Sidem Nr.	Application	Reference nr.
Stabiliser link	3360	Ford	1 361 653
		Seat	7M0 411 317 C
		Volkswagen	7M3 411 317 C

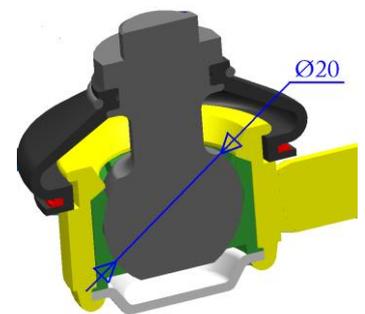
Problem:

- Play on Ball joint

Cause:

- Due to its location, this stabilizer link is exposed to all kind of external influences. When a dustcover is damaged or is not fitting perfectly, water and dirt finds its way into the joint. This causes oxidization of the ball pin, which leads to wear of the plastic cup.
- The cars who use this stabilizer link are big and heavy cars. Their weight, height, wind load ... cause high surface pressure on the ball head and makes them wear faster.

Solution:

- Use dustcover which fits perfectly along the rod.
- Enlarge ball pin diameter of the joints to reduce surface pressure.
